## Eastern Corridor Segments II and III

Combined Linwood/Eastern Interchange and US 50/Red Bank Interchange Focus Area

# US 50/RED BANK CONNECTIVITY

**Figure X-4C-1**  
**ROUNDBOUT AT COLBANK AND U.S. 50**  
**RAMP INTERSECTION**

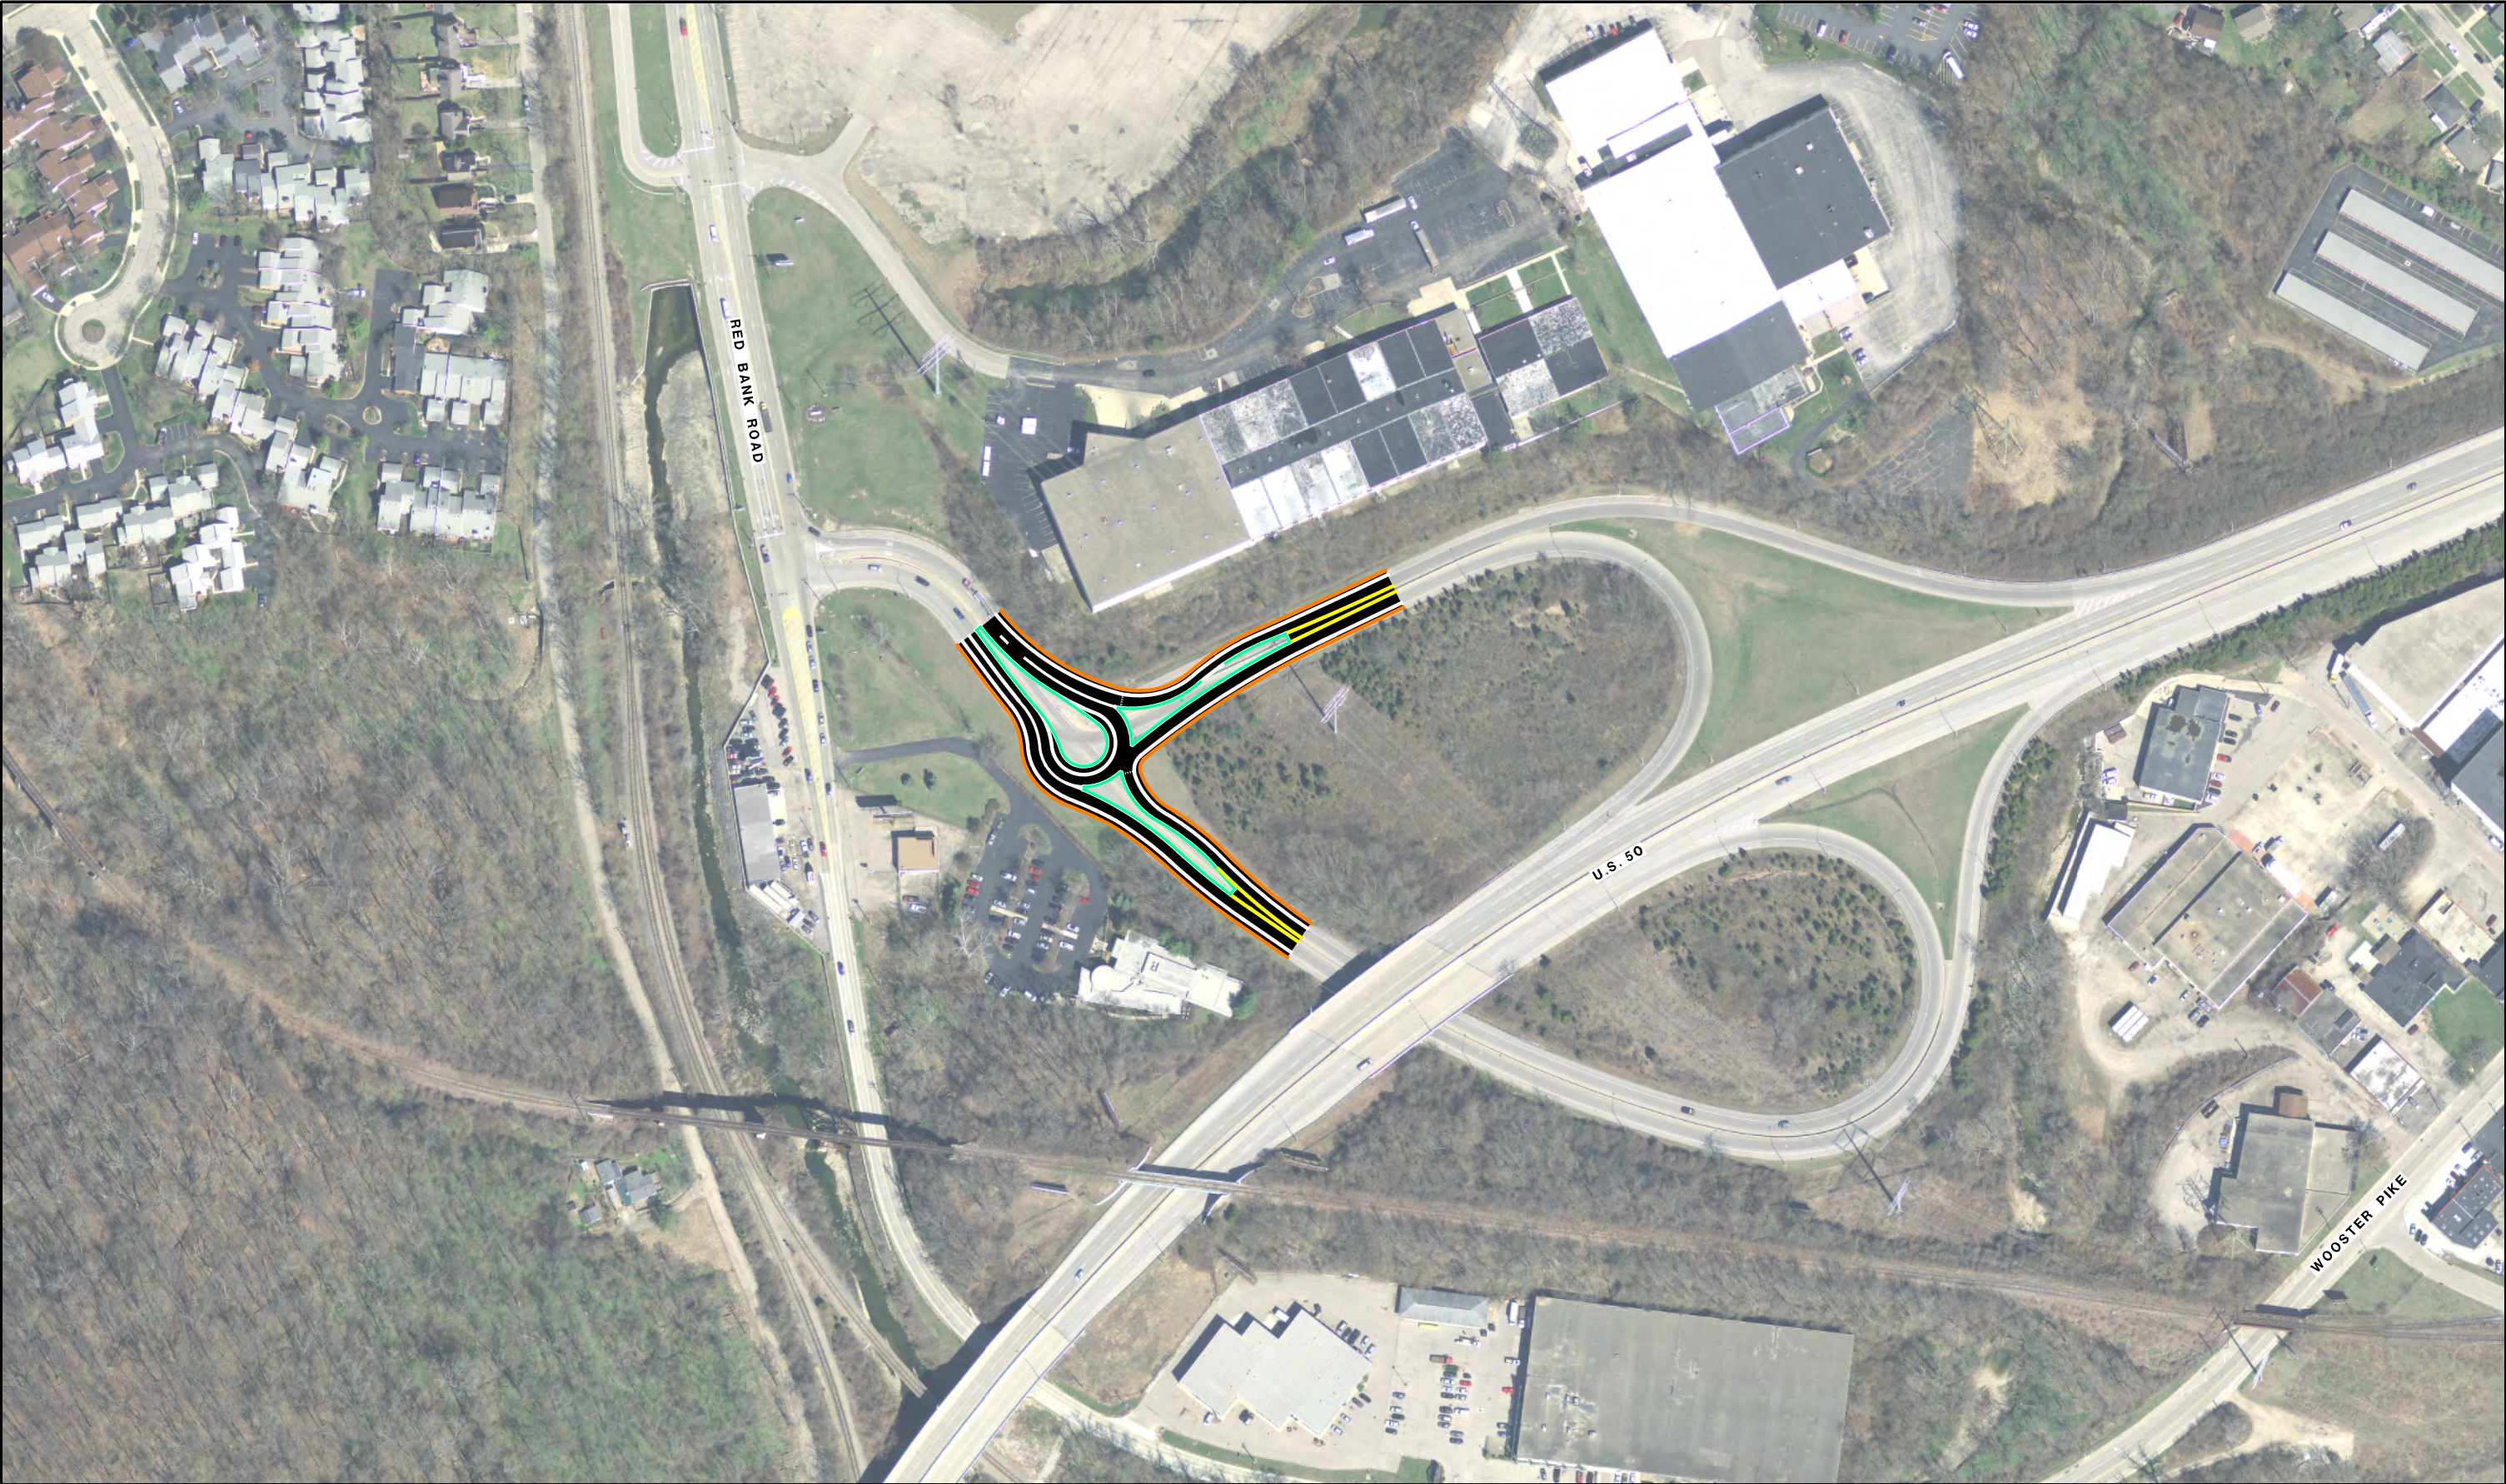
- This concept appears to work well to reduce delays during both morning and evening peak-hours.
- The concept would resolve backups from vehicles turning left by allowing left turns without having to yield to traffic coming from other directions.
- This concept is a minor project with good benefits.
- No additional comments received following the 5/22 meeting.

- No further study. This concept has similar operational and safety benefits as concept X-4c-2. However, the right-of-way impacts are greater. Therefore, X-4c-2 will be advanced instead of X-4c-1.

**Figure X-4C-2**  
**ROUNDBOUT AT COLBANK AND U.S. 50**  
**RAMP INTERSECTION**

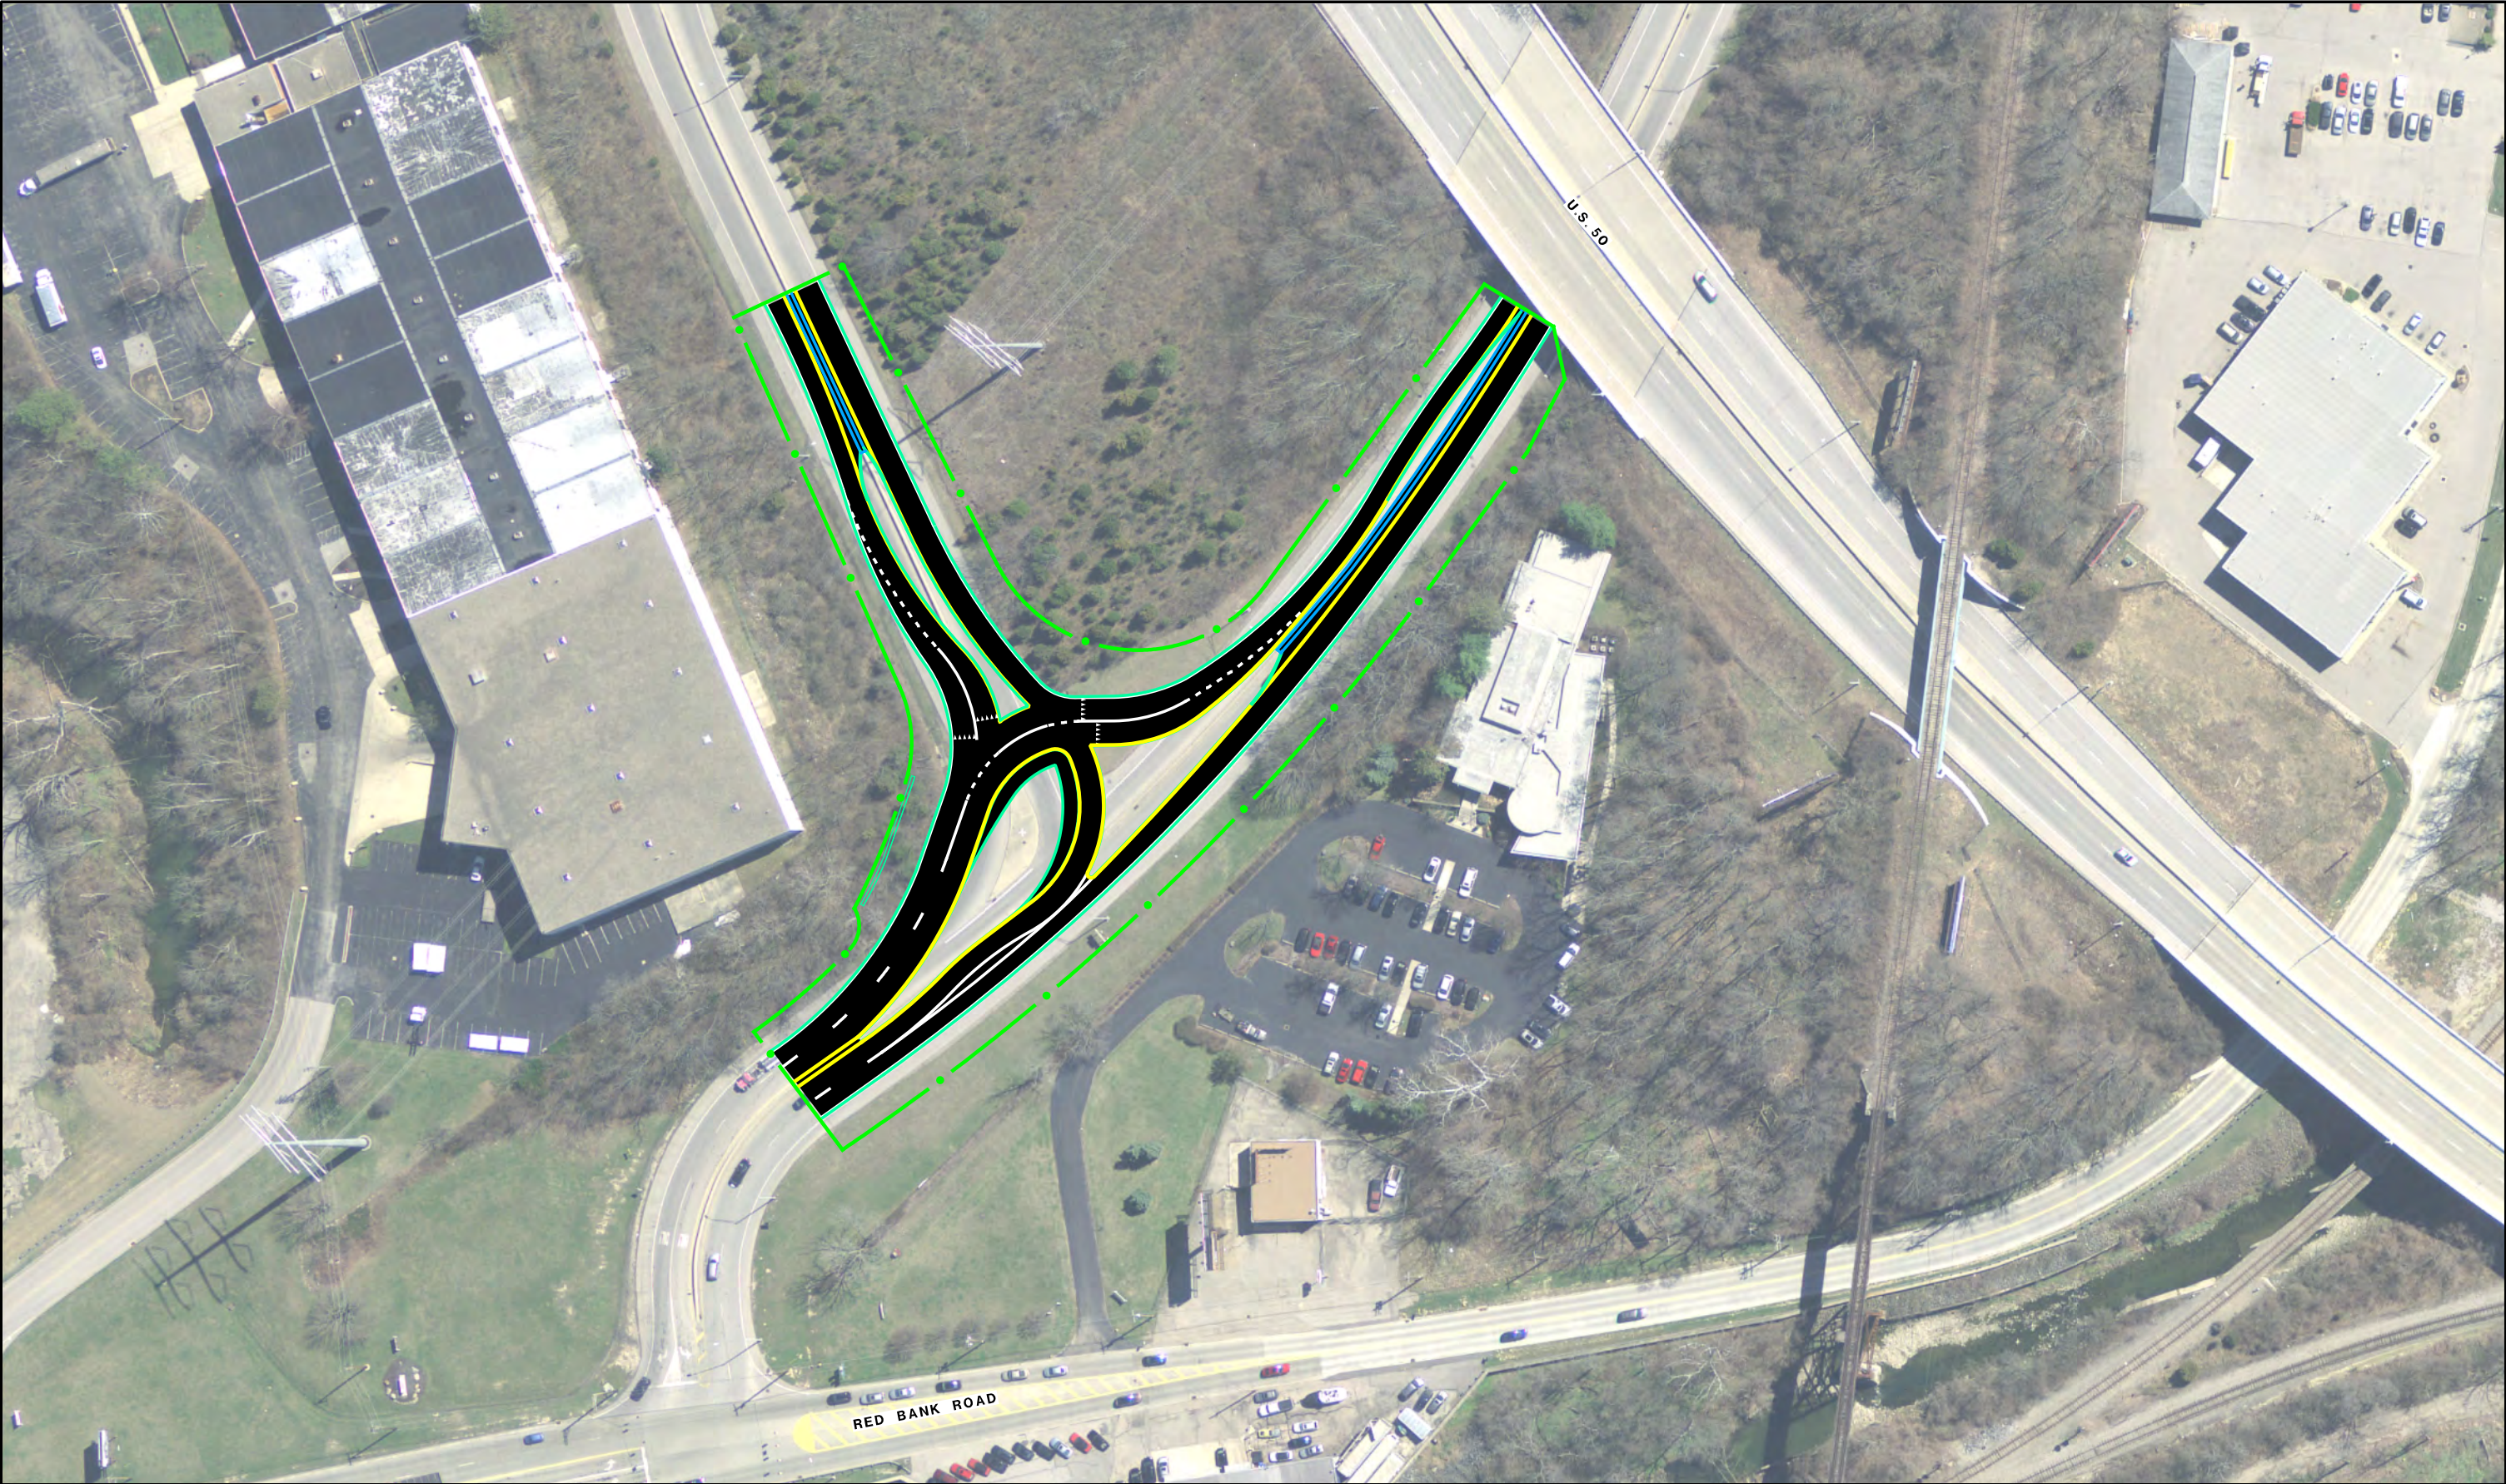
- This concept is an alternative to others designed to improve operations at the Red Bank/US 50 interchange: I-25b, I-25c, X-4a, X-4d and X-4d-1.
- A roundabout at this intersection is likely to be confusing to drivers, as traffic coming into the roundabout would be required to yield to traffic turning left.

- The committee discussed whether it would be possible to make dual left turn lanes for the turn onto the US 50 ramp.
- Matt Crim, Stantec, reported that approximately 490 cars turn left from Colbank to westbound US 50, whereas 169 cars continue straight to eastbound US 50 during the PM peak hour.
- A non-traditional roundabout at this location is considerably more expensive than the signalized intersection concept and provides less benefit.
- No additional comments received following the 9/7 meeting.

- No further study. The cost/benefit analysis for this concept is less favorable than other alternatives.
